RULE NO.: R161-23.05

NOTICE OF RULE ADOPTION

R161-23.05: Modifies the Standards Manual as follows:

Standards Manual – Series 600 – Environmental

661-4

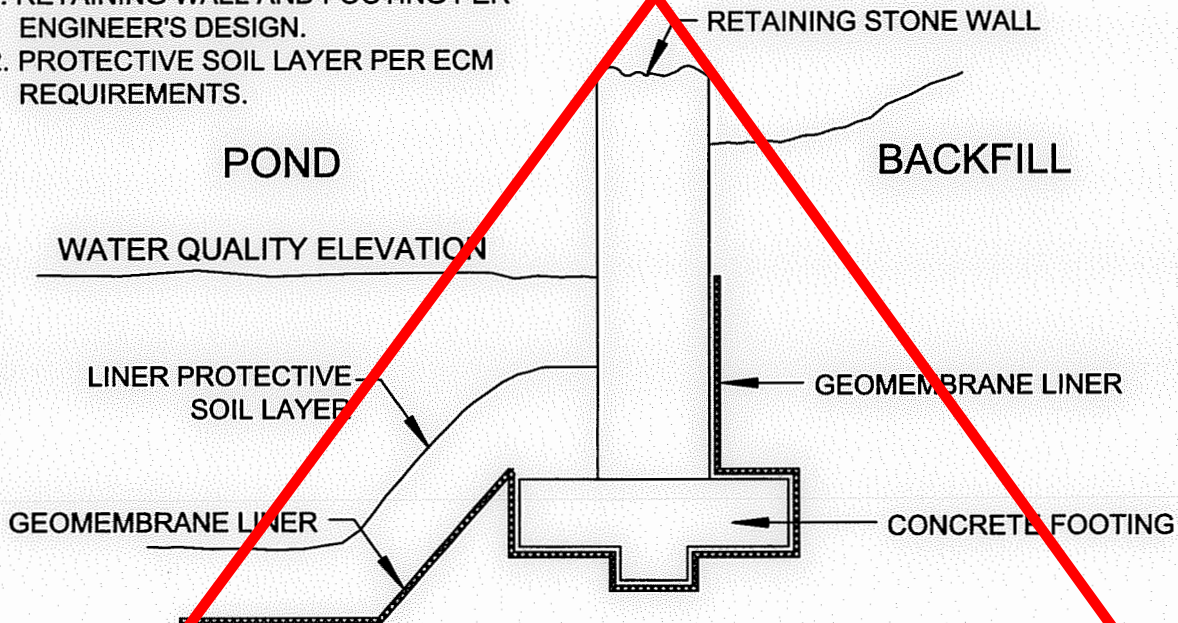
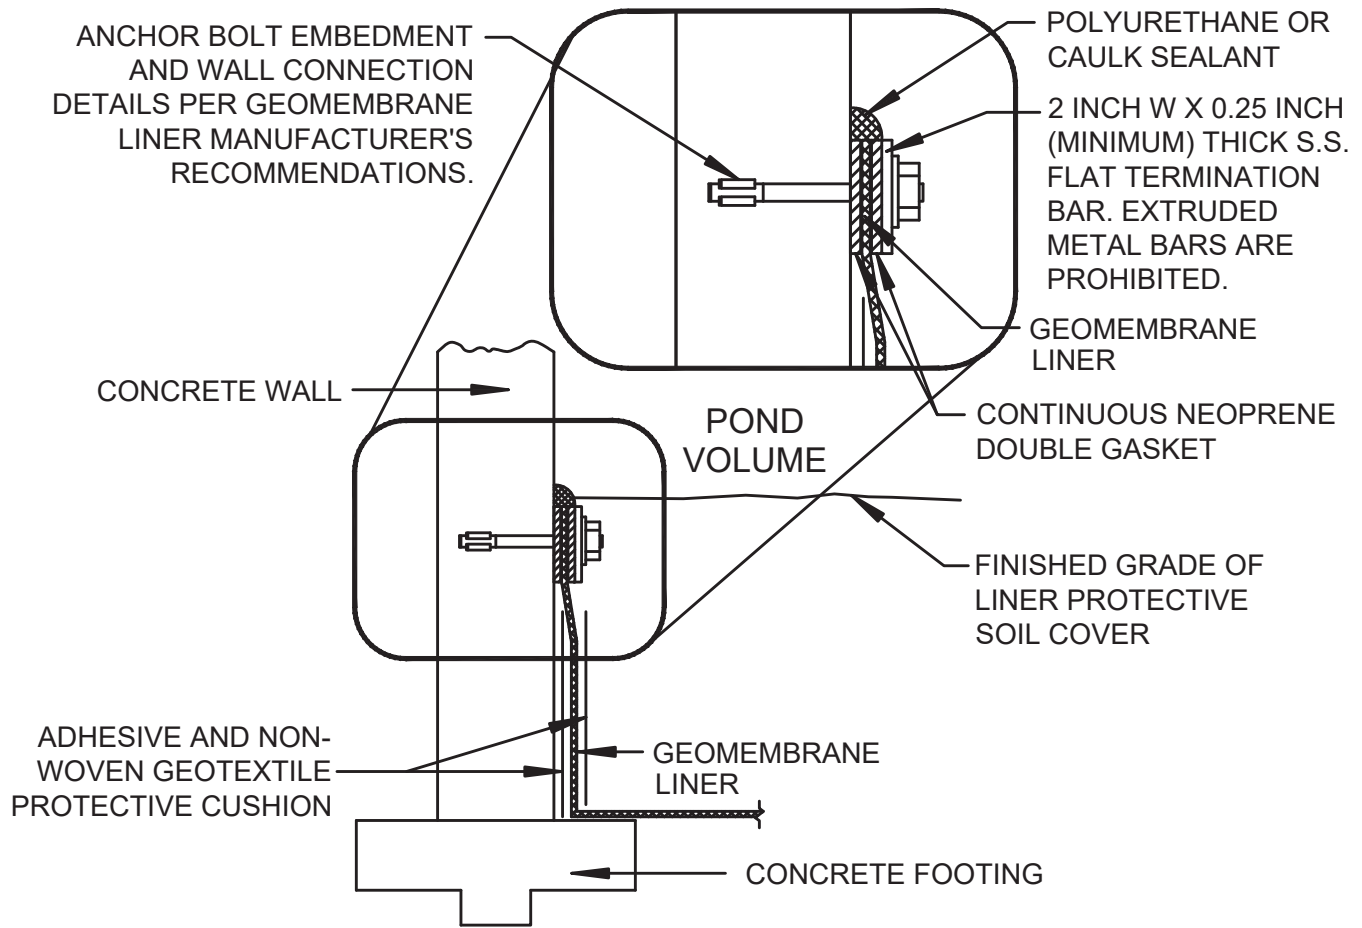
- Standard No. 661-4 – Geomembrane Liner Attachment Details: Removes this detail.
- Standard No. 661-4A – Concrete Wall Geomembrane Liner Attachment: Replaces 661-4 with an updated detail that incorporates acceptable methods for geomembrane liner attachment for placement under concrete walls.
- Standard No. 661-4B – Grouted or Mortared Stone Retaining Wall Geomembrane Liner: Replaces 661-4 with an updated detail that incorporates acceptable methods for geomembrane liner attachment for placement under grouted or mortared stone retaining walls.

REMOVE
